Virgil C. Summer Nuclear Station (VCSNS) Units 2 and 3
Combined License Nos. NPF-93 and NPF-94
Docket Nos. 52-027 & 52-028

Subject: LAR 16-10 License Amendment and Exemption Request: Shield Building Roof Changes

- Enclosure 1: Virgil C. Summer Nuclear Station Units 2 and 3 – Request for License Amendment Regarding Shield Building Roof Changes (LAR 16-10)
- Enclosure 2: Virgil C. Summer Nuclear Station Units 2 and 3 – Protected Information for Request for License Amendment Regarding Shield Building Roof Changes (LAR 16-10) – Security-Related Information – **Withhold from Public Disclosure Under 10 CFR 2.390(d)**
- Enclosure 3: Virgil C. Summer Nuclear Station Units 2 and 3 – Exemption Request Regarding Shield Building Roof Changes (LAR 16-10)
- Enclosure 4: Virgil C. Summer Nuclear Station Units 2 and 3 – Proposed Changes to Licensing Basis Documents (LAR 16-10)
- Enclosure 5: Virgil C. Summer Nuclear Station Units 2 and 3 – Proposed Changes to Licensing Basis Documents – Protected Information (LAR 16-10) – Security-Related Information – **Withhold from Public Disclosure Under 10 CFR 2.390(d)**

Figure 3-3: Current UFSAR Figure 3H.5-11 Sheet 6 with Item Labels

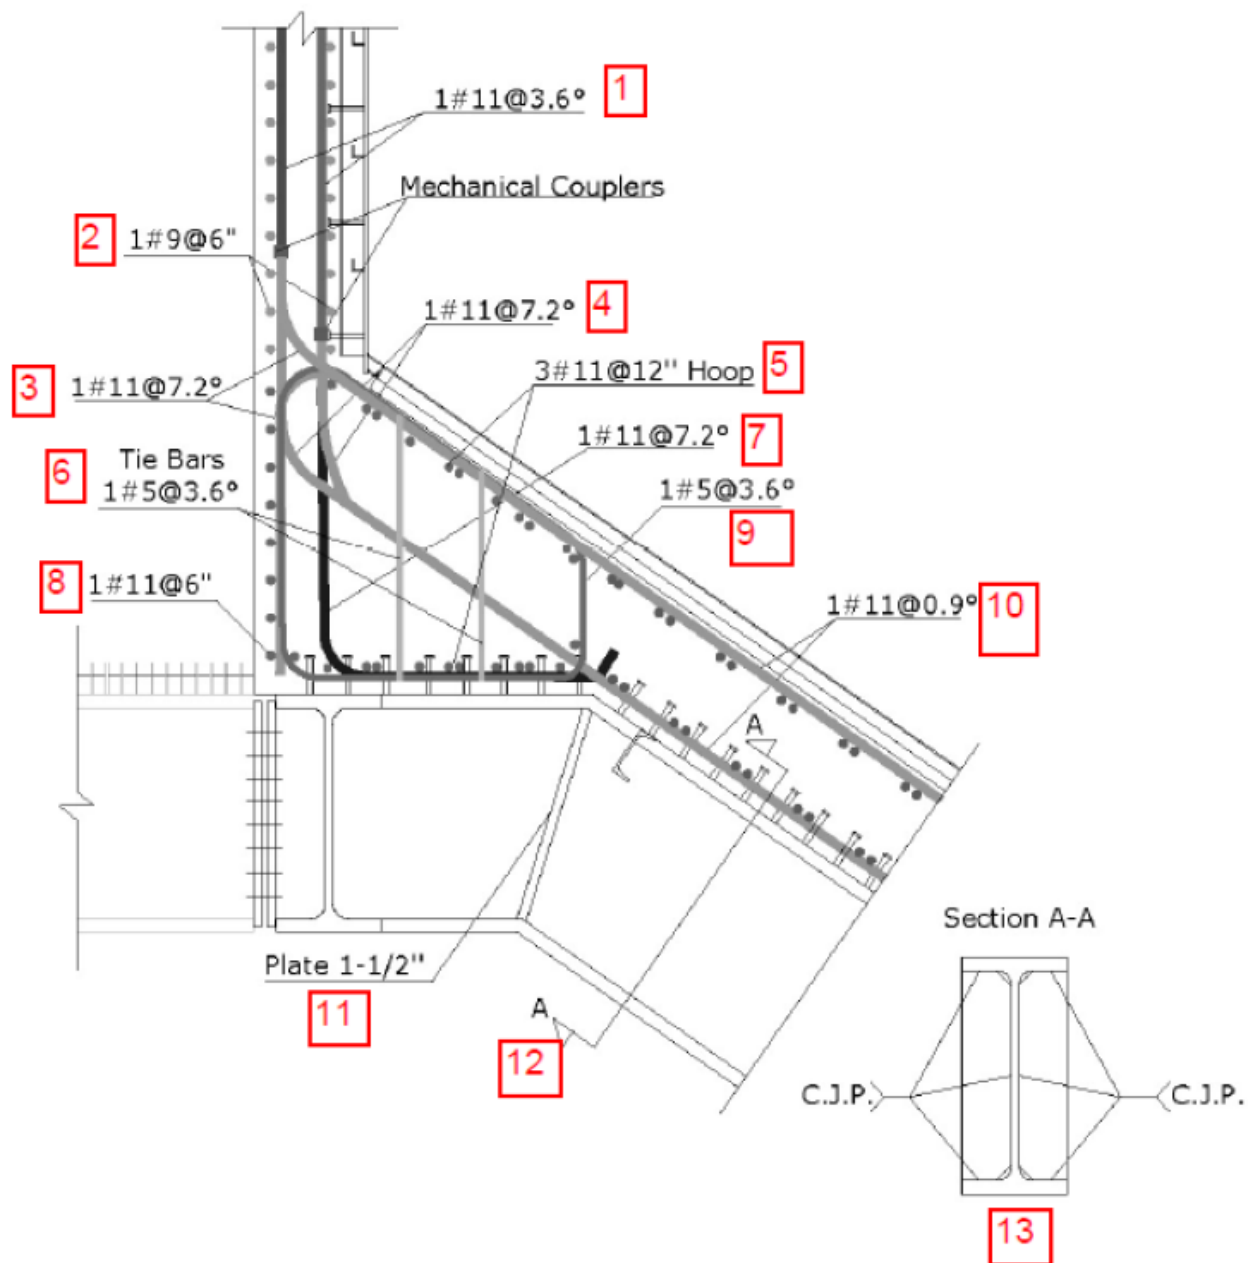
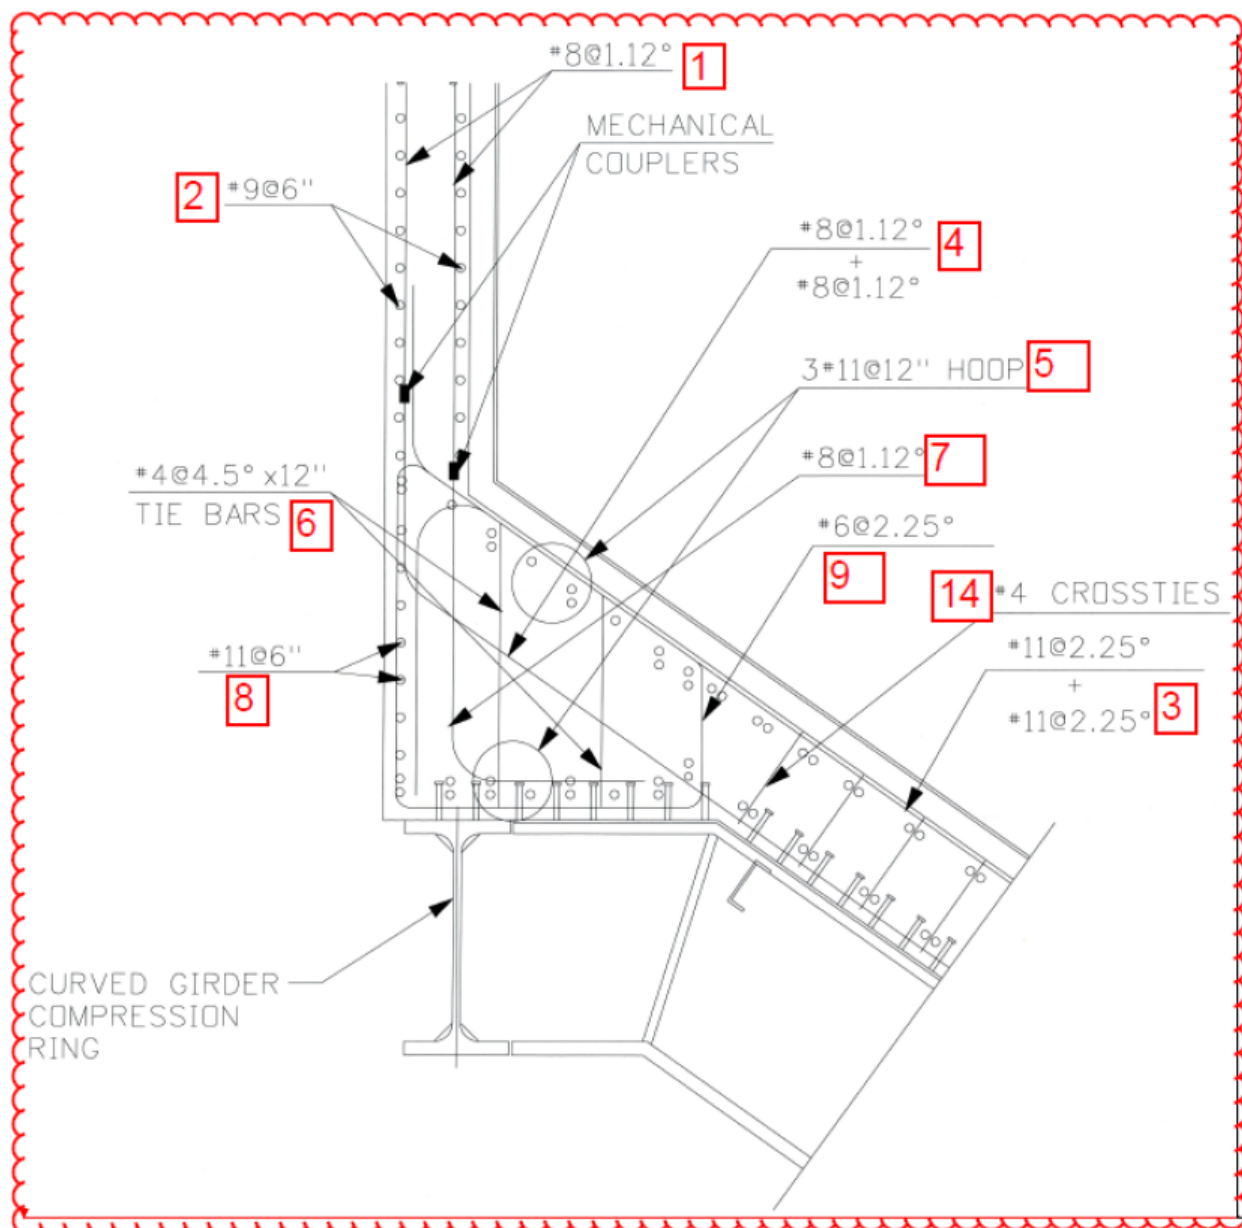
On UFSAR Figure 3H.5-11, Sheet 6 the following changes are made: the vertical reinforcement bars in the tank interior wall are changed from 1 #11 @ 3.6° to #8 @ 1.12°; the top radial reinforcement in the roof slab near the tank interior wall is changed from 1 #11 @ 7.2° to #11 @ 2.25° + #11 @ 2.25°; the bottom radial reinforcement in the roof slab near the tank interior wall is changed from 1 #11 @ 7.2° + 1 #11 @ 7.2° to #8 @ 1.12° + #8 @ 1.12°, and only one set of bottom reinforcement (#8 @ 1.12°) is connected to tank wall vertical reinforcement on the outer face and the other set of bottom reinforcement is developed into the tank wall without connecting the vertical reinforcement at inner face of the tank wall; the layout of 3 #11 @ 12" hoops at the intersection of tank interior wall to roof is changed from 2 #11 (laid out horizontally) + 1 #11 to 2 #11 (laid out vertically) + 1 #11; the tie bars at the intersection of tank interior wall to roof are changed from 1 #5 @ 3.6° to #4 @ 4.5° with 12 inches spacing; the dowels of vertical reinforcement at inner face of the tank interior wall are changed from 1 #11 @ 7.2° to #8 @ 1.12°, and the vertical reinforcement bars at inner face of the tank wall are all connected to the dowels instead of partial connecting to dowels and partial connecting to the bottom radial reinforcement in the roof; the closed stirrups at the intersection of tank interior wall to roof are changed from #5 @ 3.6° to #6 @ 2.25° and enclose the hoop reinforcement on the side surface of the intersection area; the reinforcement of 1 #11 @ 0.9° represented for the top and bottom radial reinforcement in roof at half way between the PCS interior and exterior walls is removed

as it is not applicable to this figure; the crossties information in the roof slab “#4 crossties” is added to match the design documents. All changes meet the requirements of ACI 349. In order to better visualize the changes in UFSAR Figure 3H.5-11 Sheet 6 one by one, Table 2 is provided below to summarize the changes with item labels. The design elements in both current and proposed UFSAR Figure 3H.5-11 Sheet 6 are labeled with numbers in Figure 3-3, Figure 3-4 below.

UFSAR Figure 3H.5-14 Elevation View of Tension Ring and Air Inlets - Revise information as shown below.

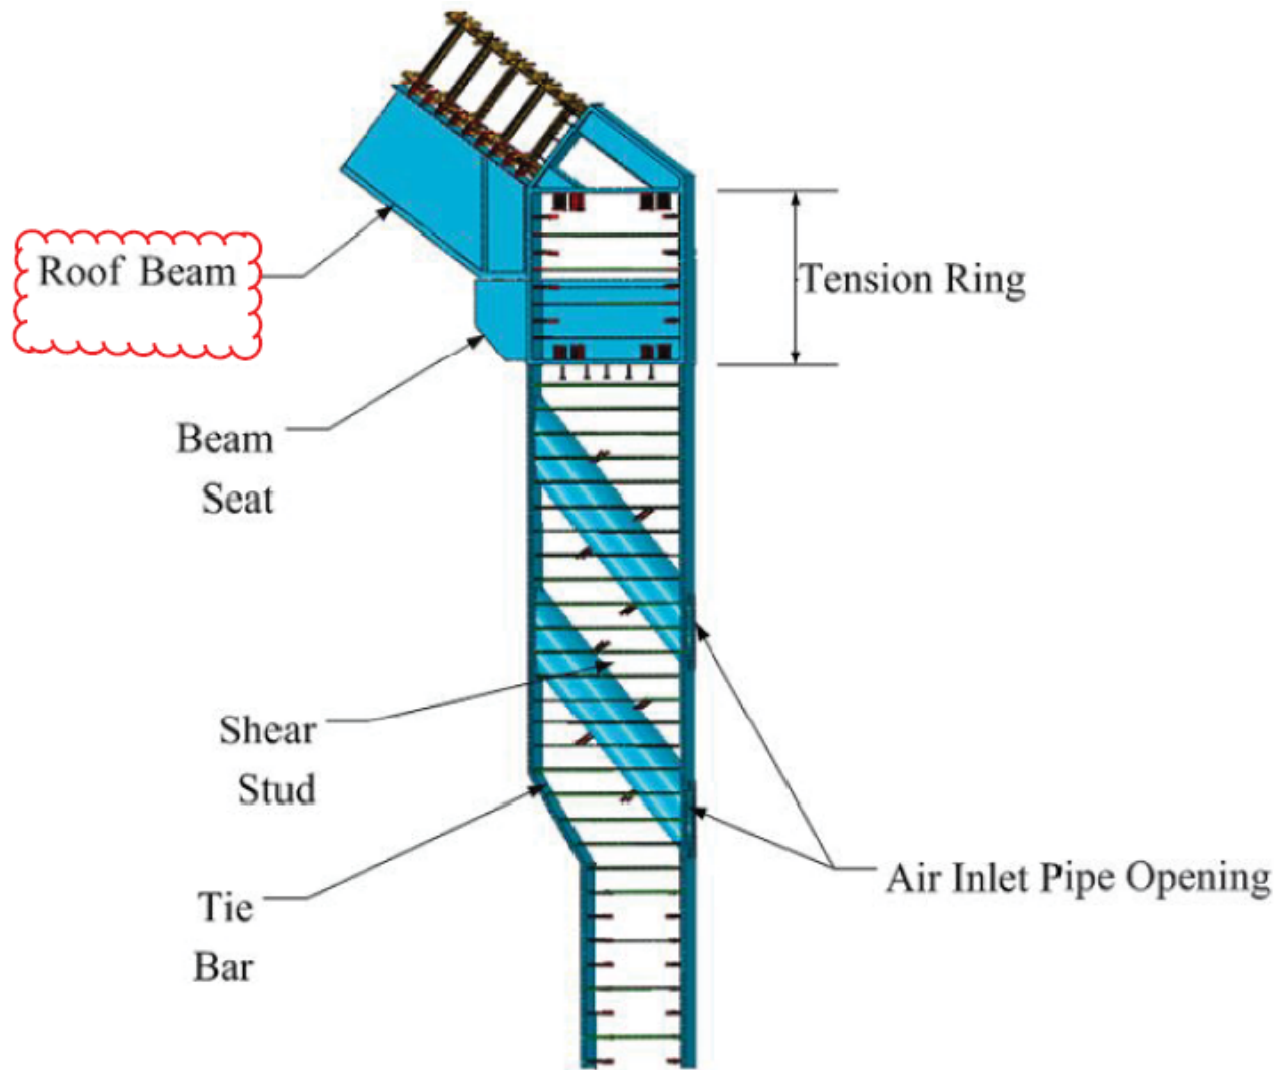
- Remove reference to beam size. CA#1
- Change roof beam designation. CA#4F

UFSAR Figure 3H.5-15 Shield Building Tension Ring - Revise information as shown below.

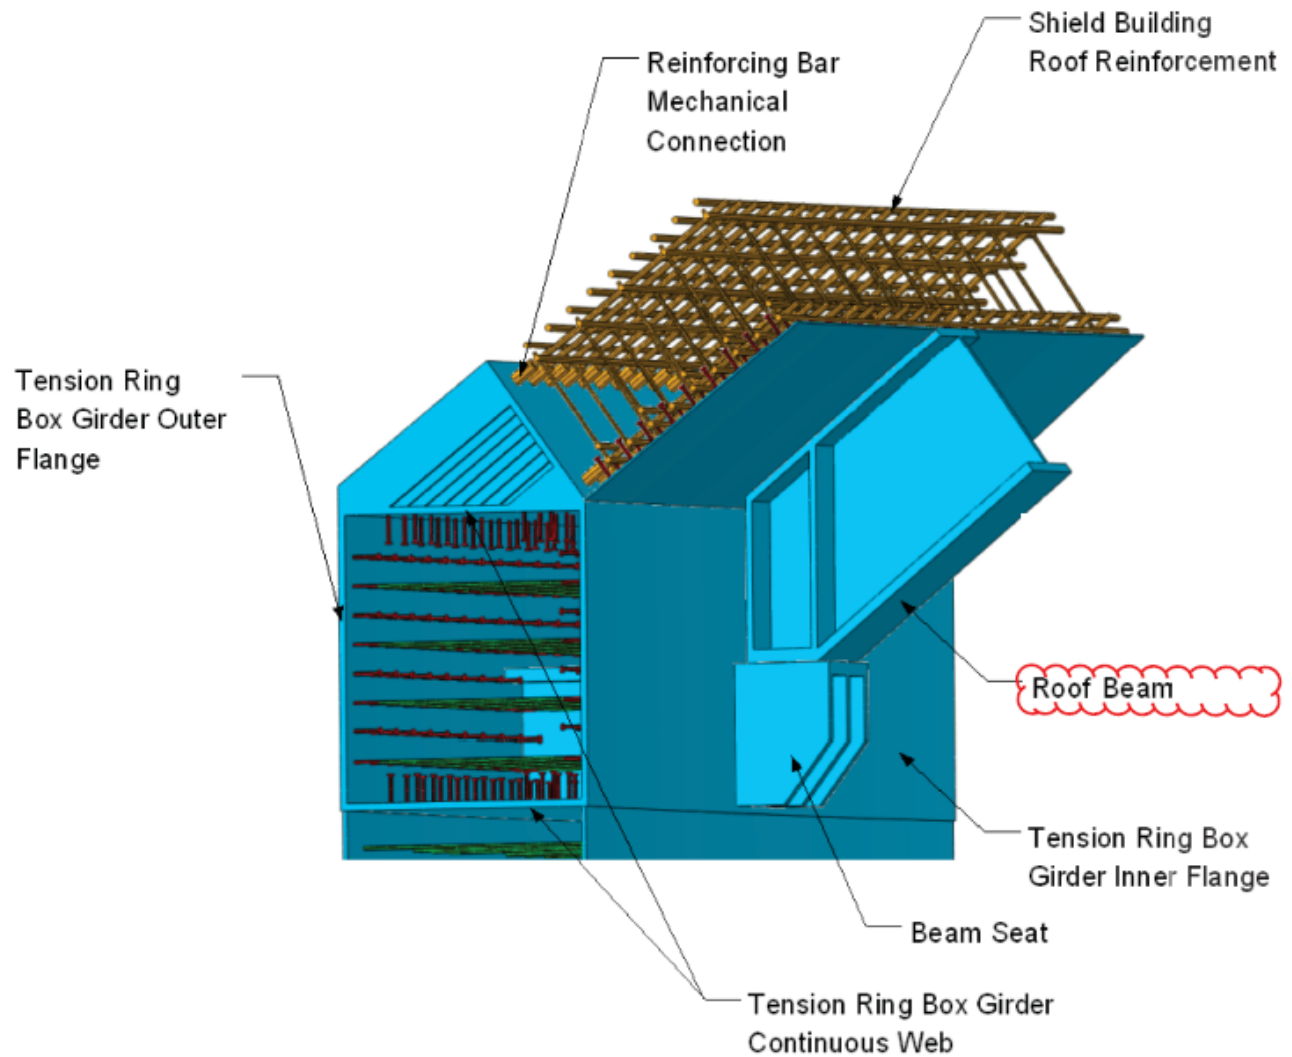
- Remove reference to beam size. CA#1
- Change roof beam designation. CA#4F

UFSAR Table 3H.5-9 (Sheet 1 of 3) Shield Building Roof Reinforcement Summary (Tension Ring) - Revise information as shown below (figure blow-up is shown on the following pages).

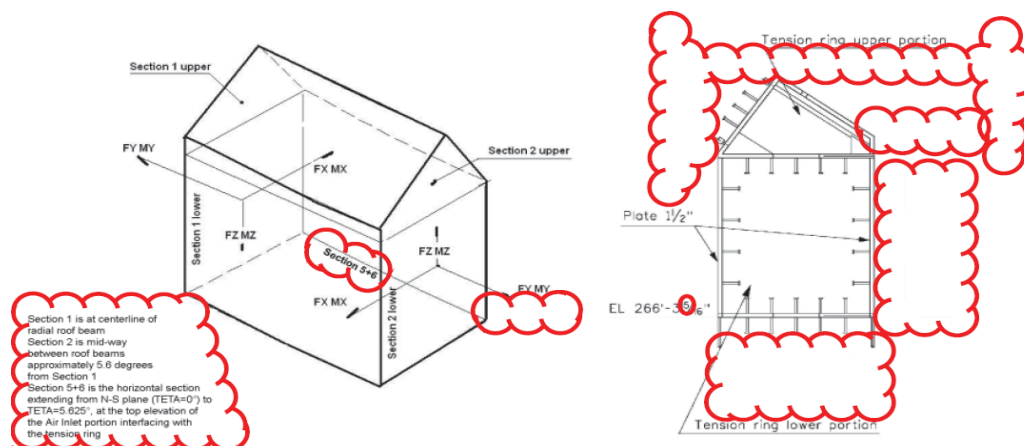
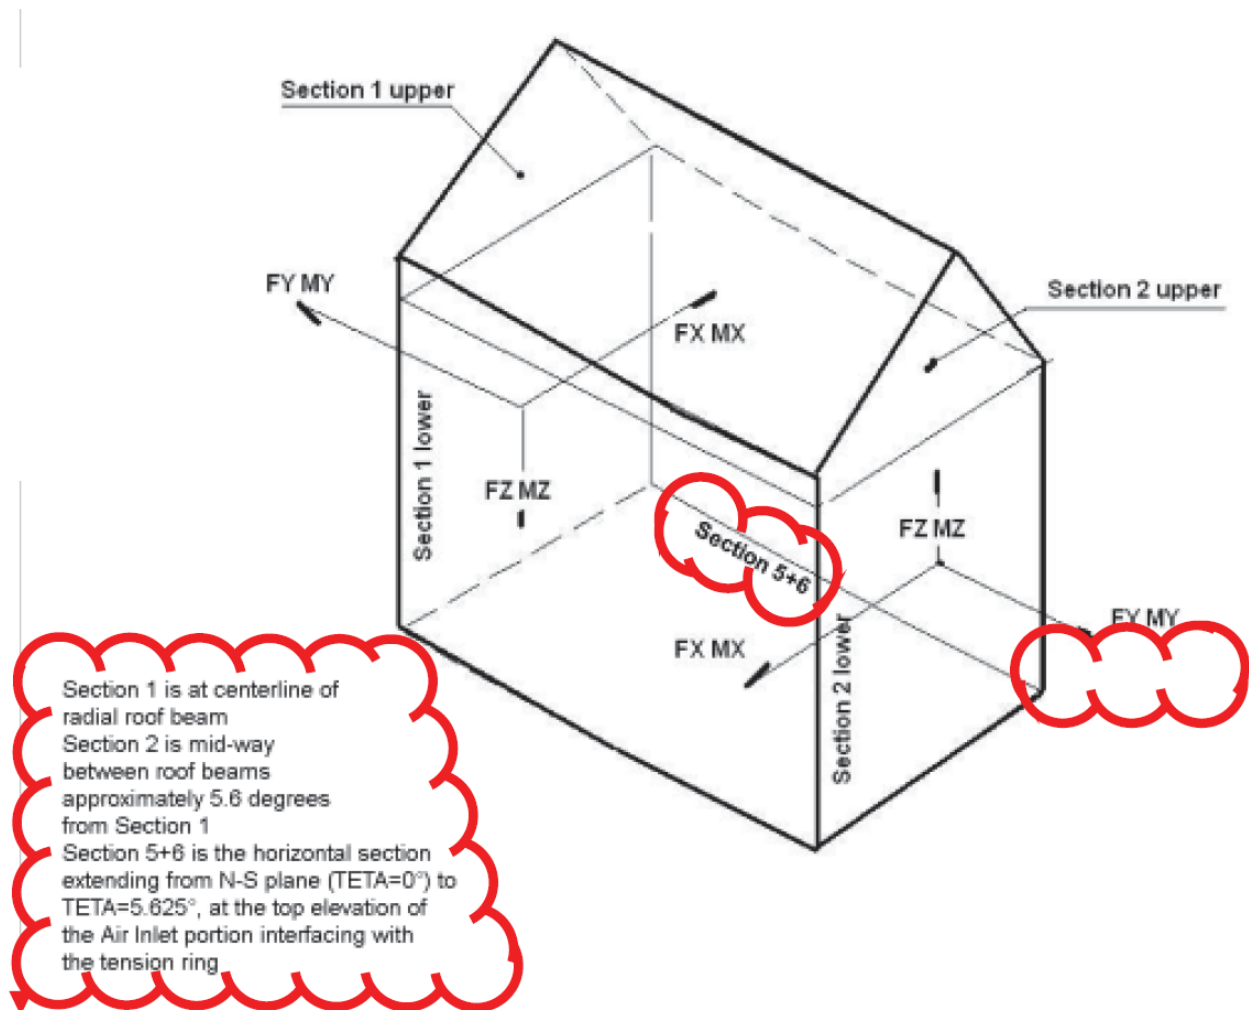
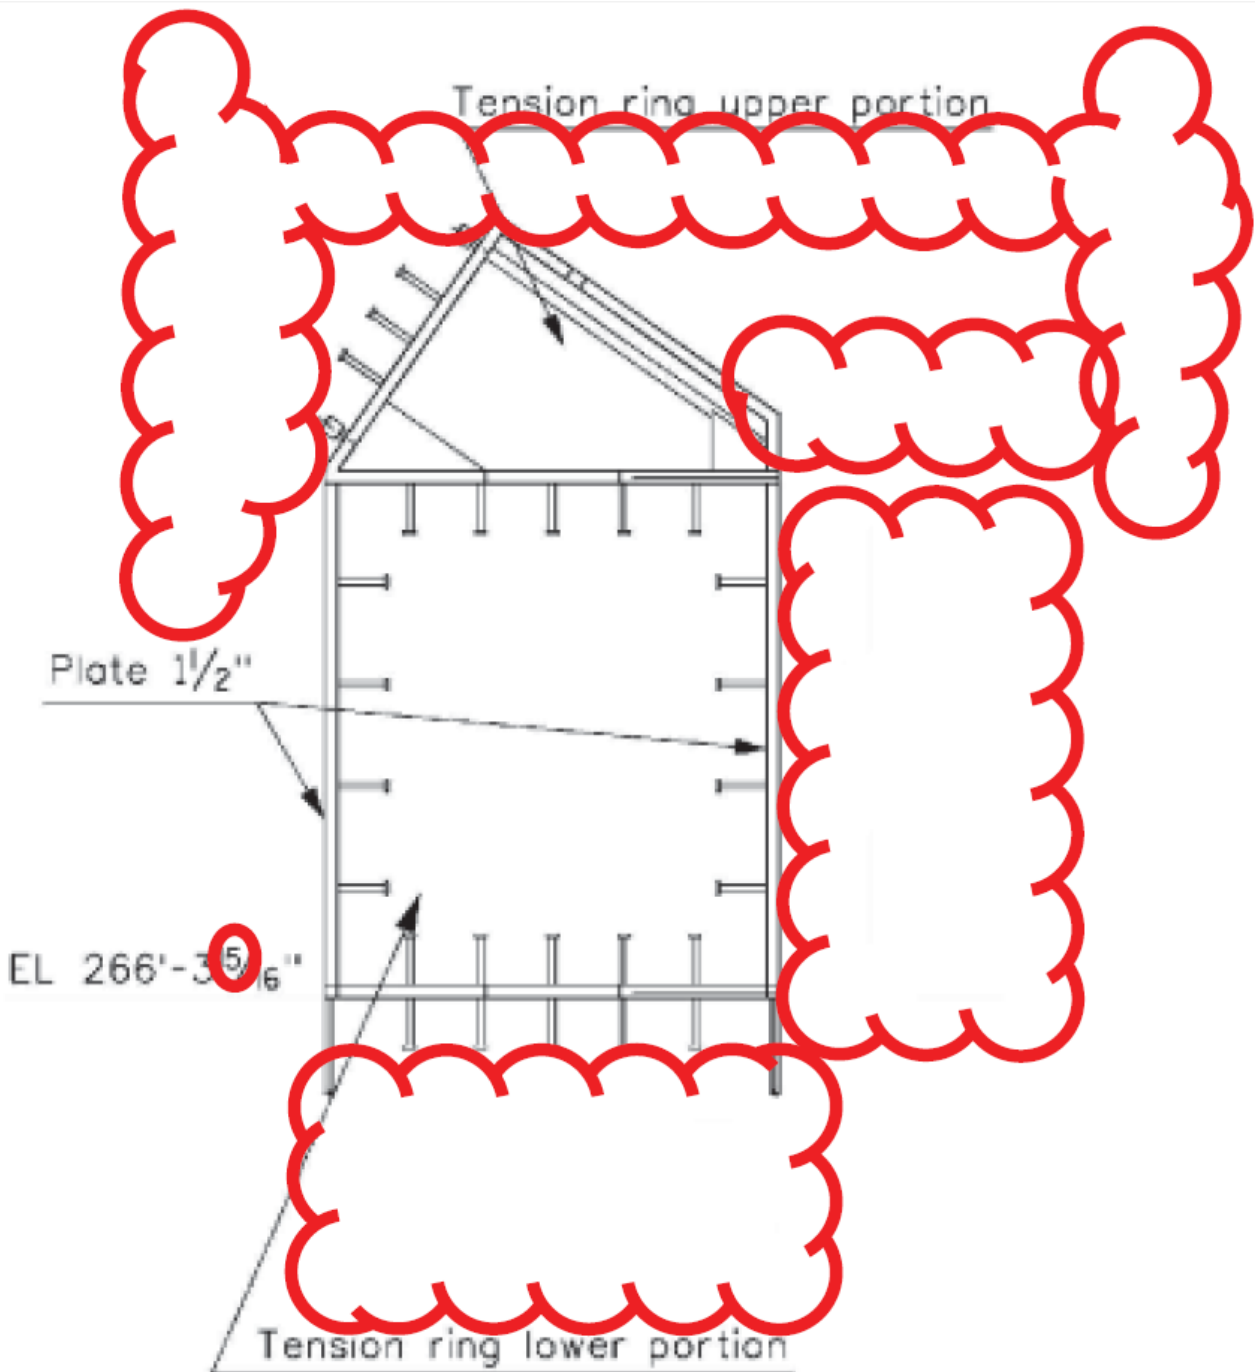
1. Revise values in table and the numbers of governing load combinations. CA#3
2. Remove dimensions from the locator figures. CA#4A
3. Add a legend to the table sketches to identify the location of the sections. CA#4A
4. The tie bar is renamed. CA#4D
